MONTGOMERY COUNTY HISTORIC PRESERVATION COMMISSION
STAFF REPORT

Address:	10 Philadelphia Avenue, Takoma Park	Meeting Date:	6/24/2020
Resource:	Contributing Resource Takoma Park Historic District	Report Date:	6/17/2020
Applicant:	Susan Montgomery Rick Vitullo, Architect	Public Notice:	6/10/2020
Review:	HAWP	Tax Credit:	partial
Case Number:	37/03-20II	Staff:	Dan Bruechert
Proposal:	Porch modifications and window replacement

PROPOSAL

PROPOSED SIDE ELEV. (PARTIAL)
 $\frac{1}{4}'' = 1'-0''$

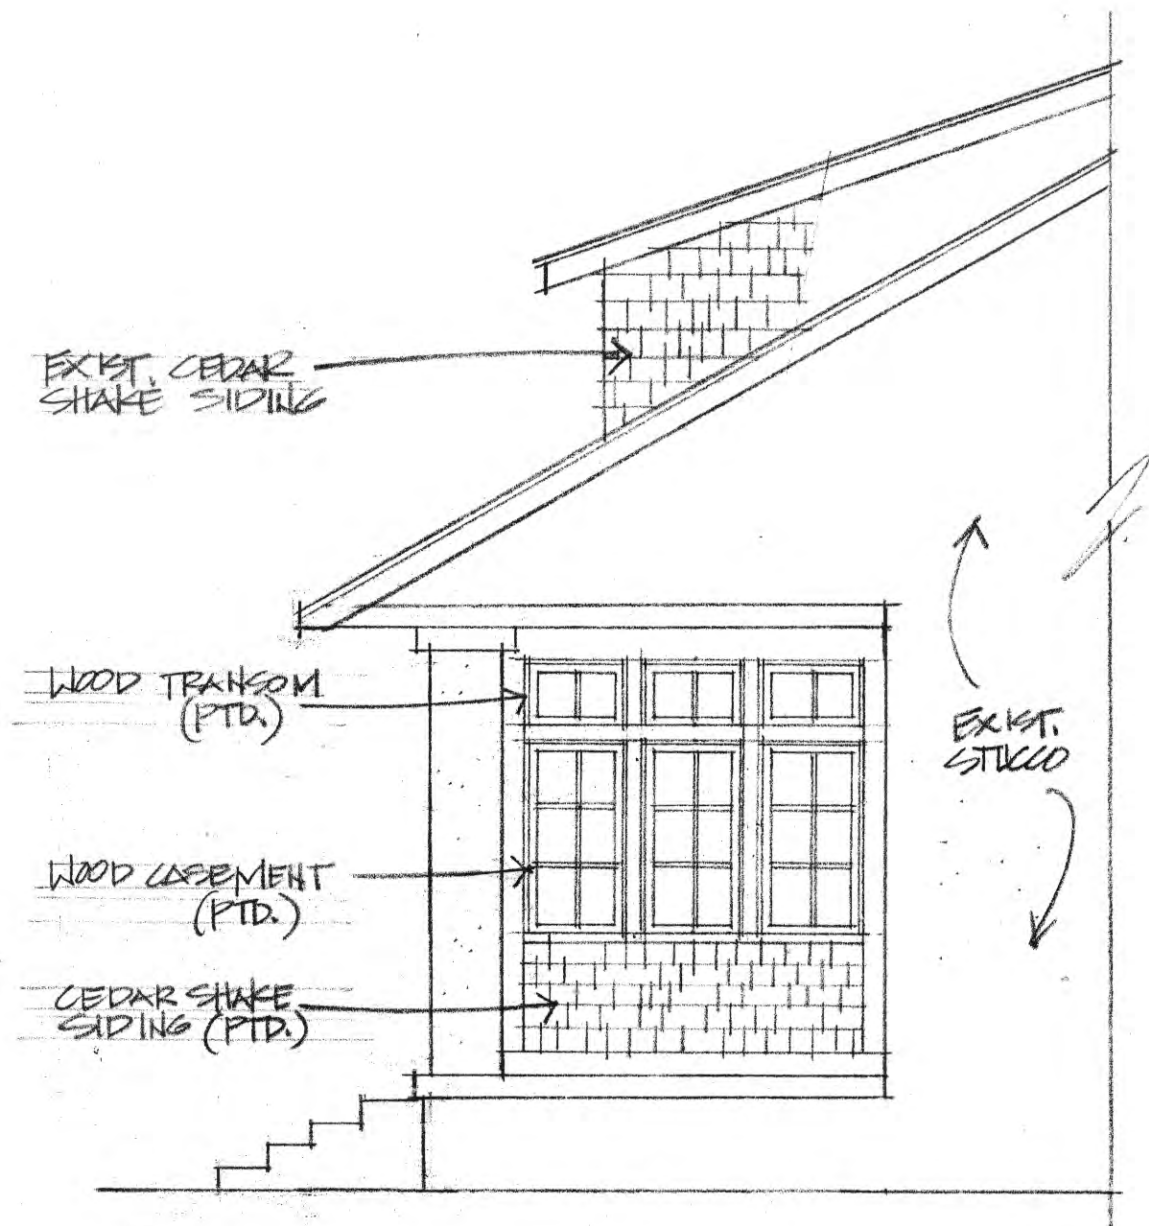
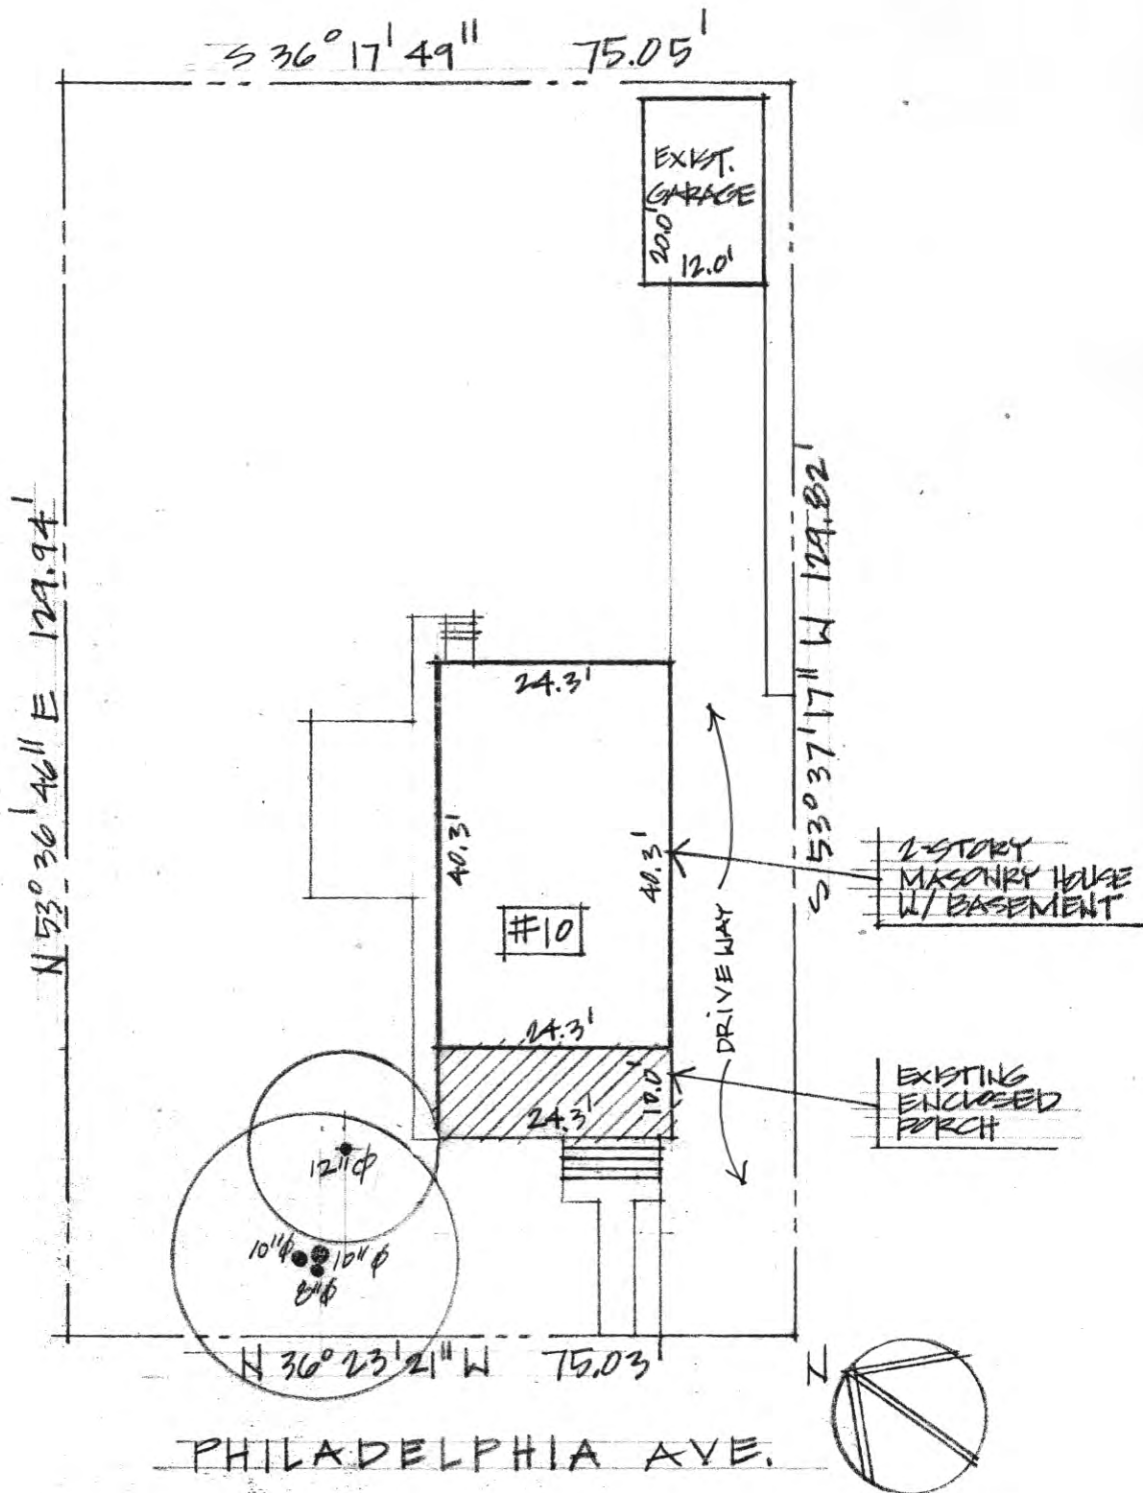
In place of the existing enclosure, the applicant proposes to install six-lite wood casement windows with a transom above. Below the windows, the applicant proposes to install cedar shake to match the exterior treatment of the second-floor shed dormer. Finally, the applicant proposes to relocate the historic front door to the exterior of the porch.

Staff finds that a large number of bungalow porches within the Takoma Park Historic District have been enclosed without diminishing the overall character of the District (see the *Design Guidelines*). The proposed work will maintain an enclosed porch, but with compatible materials and in a configuration that is consistent with the style and period of the resource. Additionally, Staff finds that the design of the replacement porch enclosure, with an increase in the amount of glazing and preservation of the stucco porch columns, retains the character of the porch and could be reversed at a future date if desired. Staff finds the porch enclosure is consistent with 24A-8(b)(2) and (d) and the *Design Guidelines*.

Staff recommends that the Commission approve the HAWP application with the condition that the exterior stair railings be constructed out of wood; under the Criteria for Issuance in Chapter 24A-8(b)(1), (2), and (d) having found that the proposal, is consistent with and compatible in character with the purposes of Chapter 24A; the *Takoma Park Historic District Design Guidelines*;
